CITY OF CROSSLAKE

PUBLIC HEARING NOTICE

Variance for:

STAFF REPORT

CERTIFICATE OF SURVEY

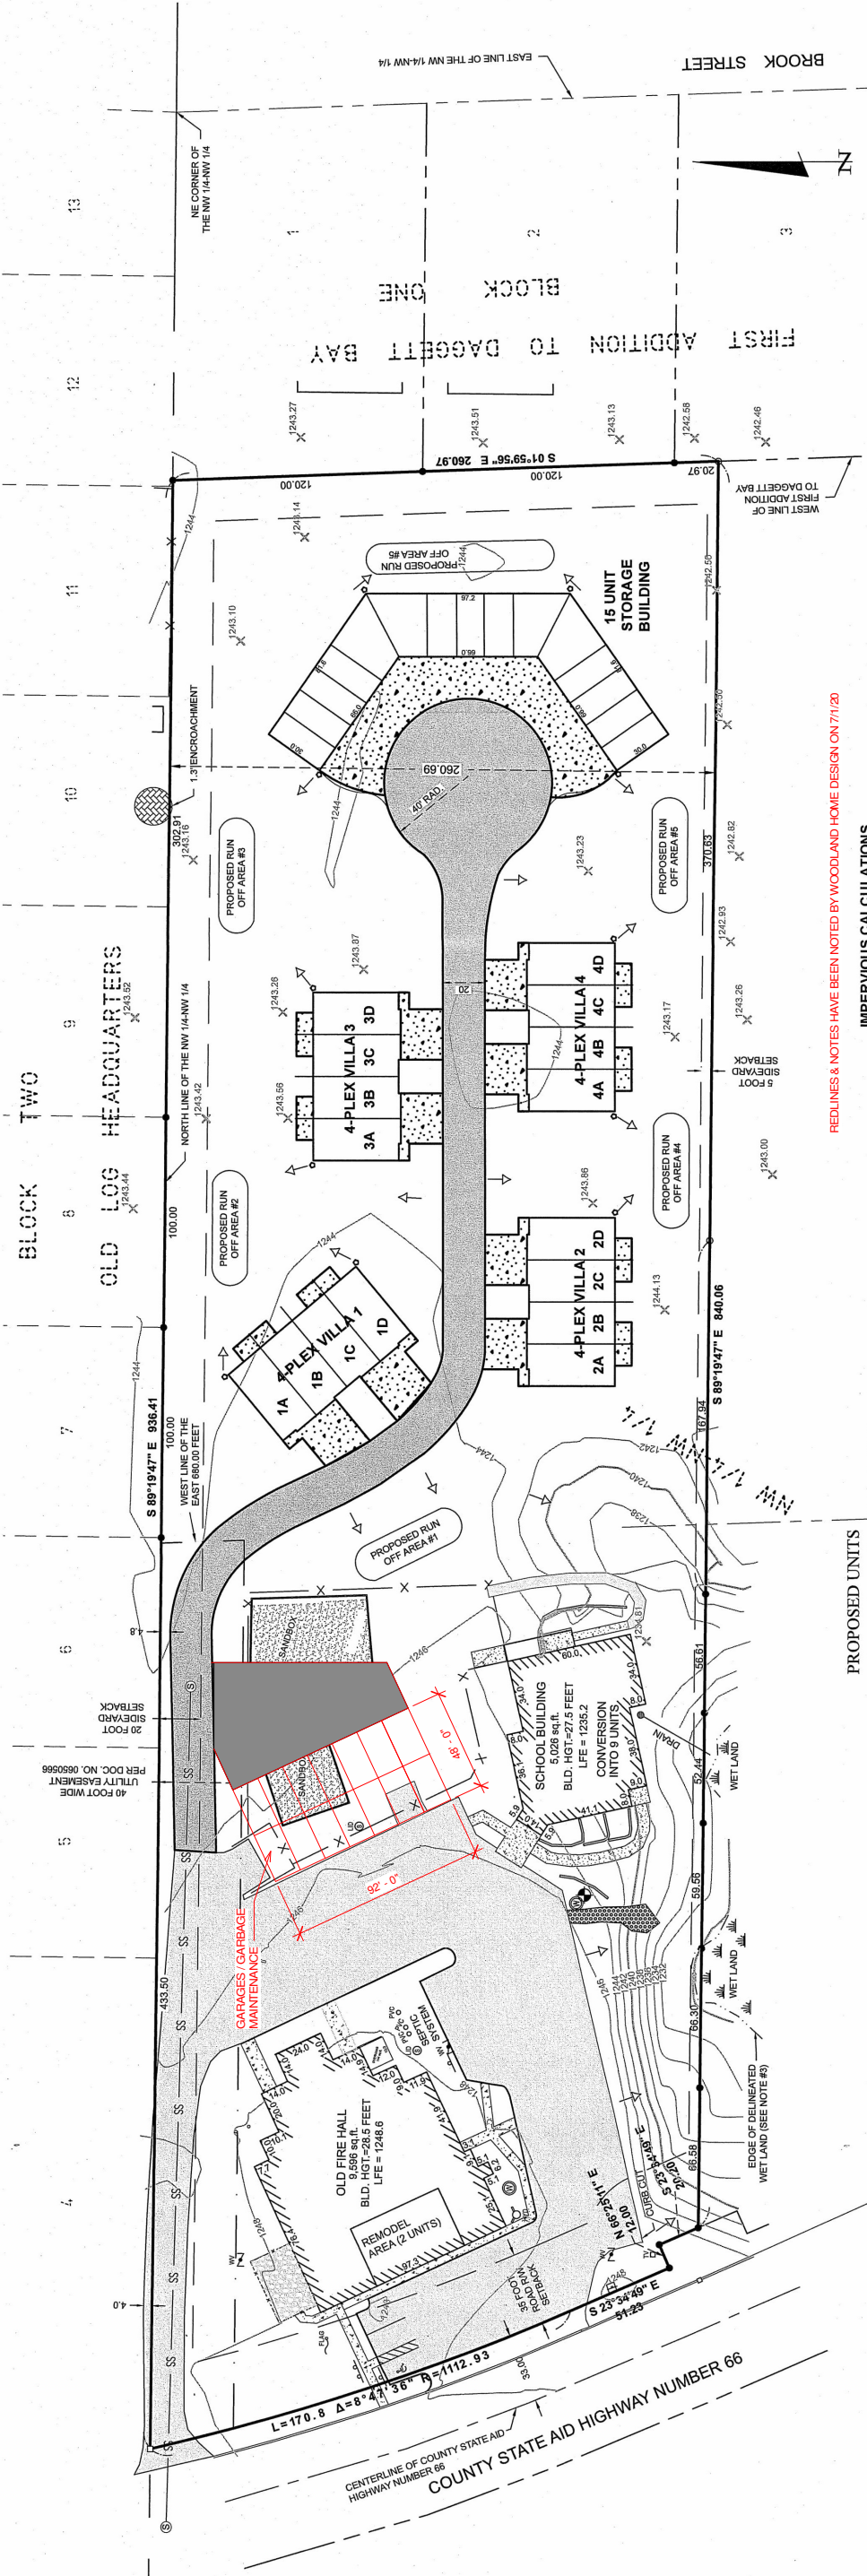
It looks like it will the north entrance will change to a city road. Will that be the case? The connection may need to be widened to reflect that change. Drainage shouldn't be directed to CSAH 66 and contained on-site. The southern entrance is one of those very wide, free-for-all types that should be narrowed down to a standard one. We should also discuss the sidewalk that leads to CSAH 66, and the possibility of getting rid of that crosswalk that was put in for the school. Additional comments may be sent prior to April 21.

I'm not sure on the north entrance becoming a city street and will defer to the city on that one. I would assume that would only be needed when the additional buildings are constructed.

There won't be any additional drainage to CSAH 66 from this development.

If adjusting the south entrance is more safe, then it should happen. Will assess further on-site soon.

I'd like to keep the "cross-walk". There is and will continue to be pedestrian traffic crossing in this area. Not only for the Sundance Developments, but other events throughout the year (car show, fire fighters events, etc) that use the city property and have parking along the road. I feel it helps funnel the foot traffic to that crosswalk, which is safer for the people and easier for the vehicles passing thru.

CONSTRUCTION DRAWING OF RECORD
PROJECT ENGINEER: A. W. Dwyer DATE: 11-8-04
HEAD OBSERVER: [Signature]

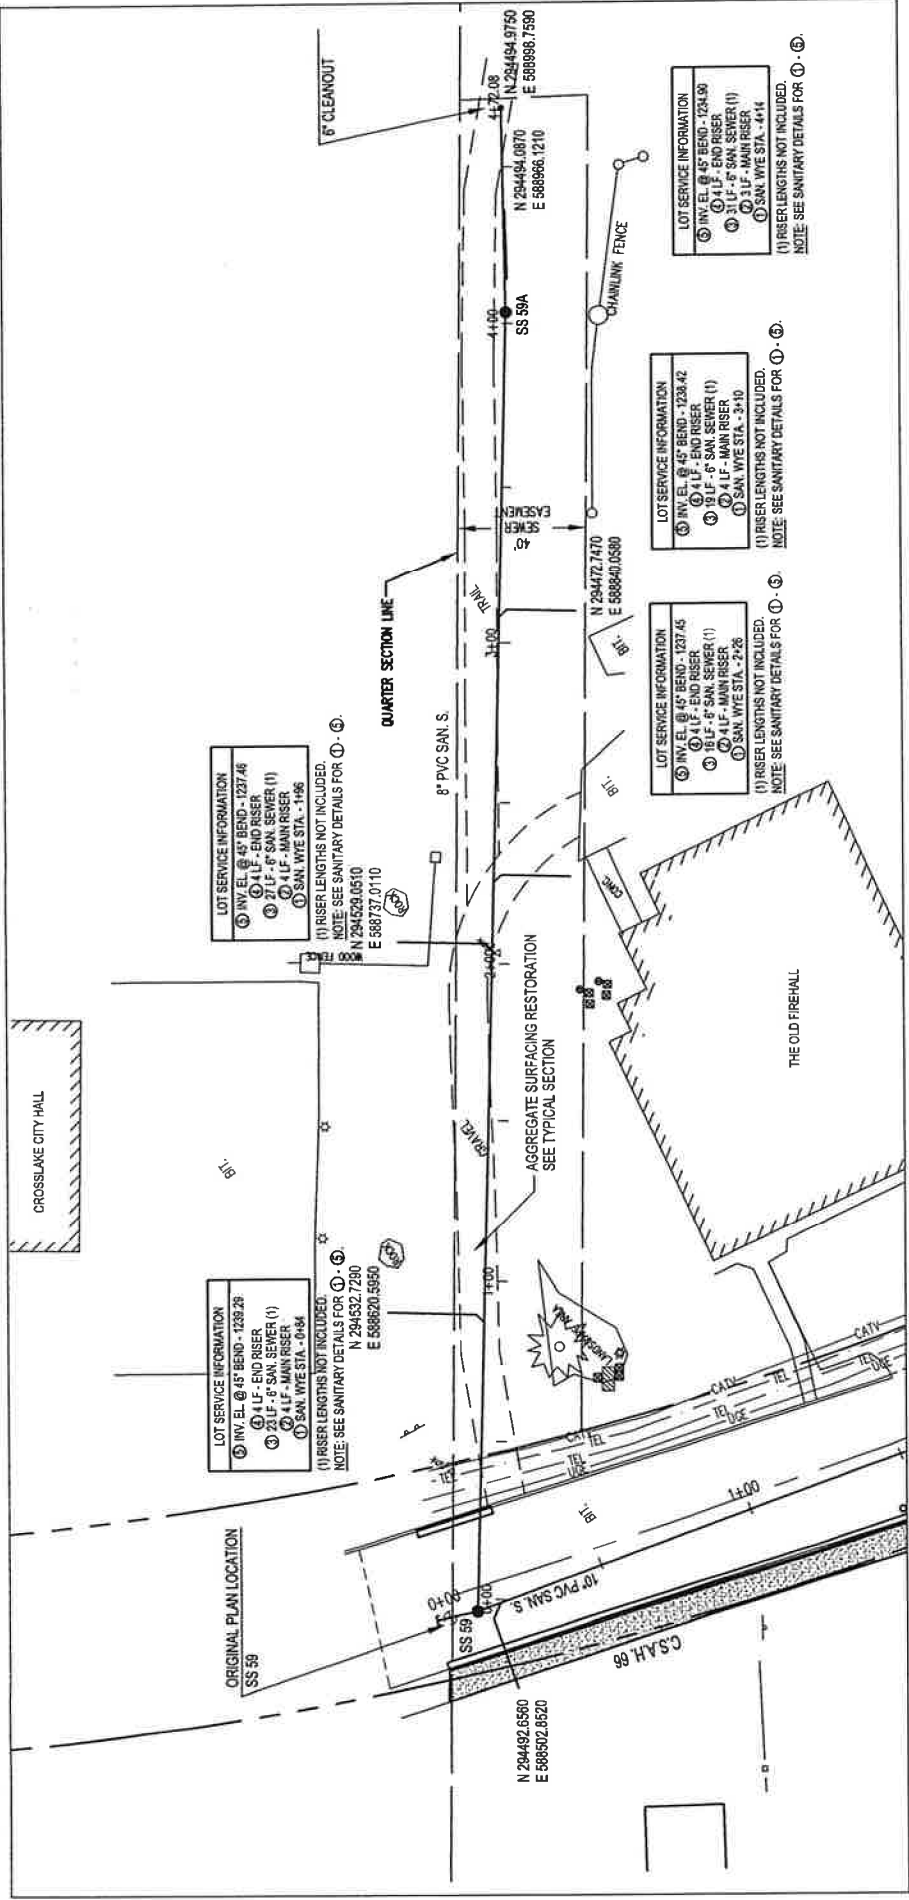
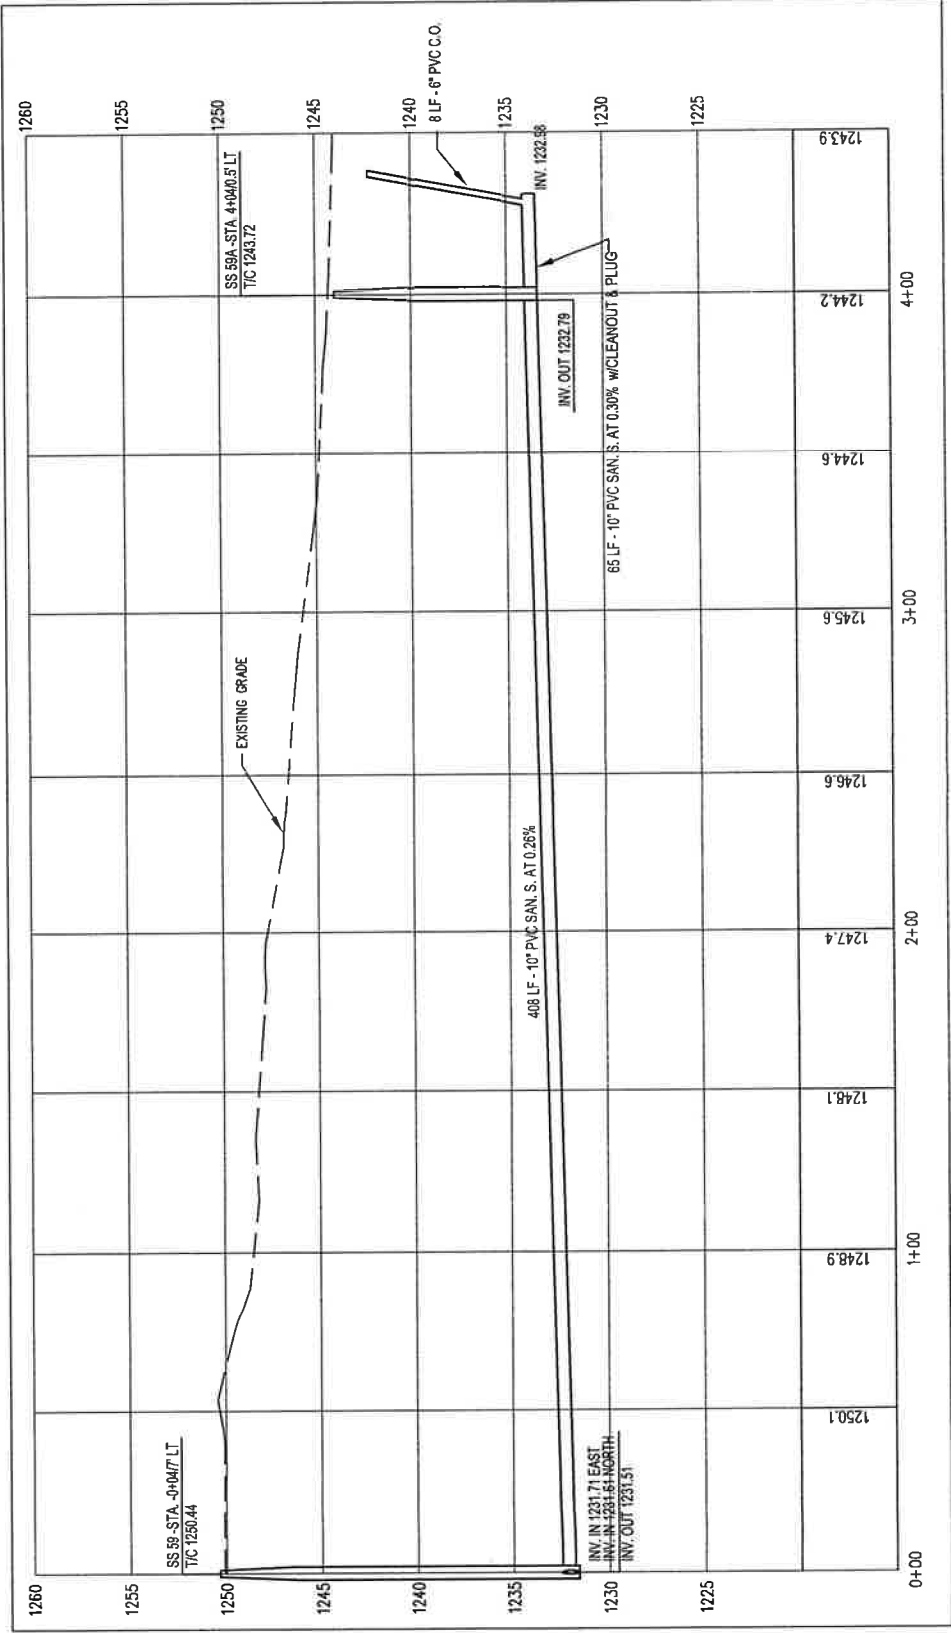
Attached is a copy of the sanitary sewer record drawing. There is a 40-ft wide sanitary sewer easement as shown with sanitary sewer installed approximately 430 feet into this property. This is a 10-inch diameter main for the purpose of accepting flows from an expanded service area to the east at some point in the future. Now would be the opportunity to extend and retain sewer easement the full length of the property along the north side to preserve this space for extension.

The City should approve the connection point(s). Alternatively, the developer may see a benefit to having the City sewer routed through the development, permitted and maintained by the City as a sewer extension rather than maintaining their private collection system. Either way, the City should have continuous utility easement to the east boundary of this property. The same principle would be true for internal access drives. If the developer intends to turn the street over to the City, then it would have to meet City standards. If private, then we recommend a minimum of 20 feet in pavement width (no on-street parking) and an additional 10 feet of clear zone on each side to ensure sufficient access for fire/ambulance and snow storage. The cul de sac should have a minimum 40-foot radius. The fire chief should have input on the access plan.

We concur with Mark's comments regarding drainage; this must be accounted for on the property. Off-street parking for tenants/owners of the units should be included in the site plan. Water wells (qualified as deep wells) for these buildings will need to be located a minimum of 50 feet from a sewage collection line (including the future extension of the City main). The Public Works Commission should review the utility and street factors.
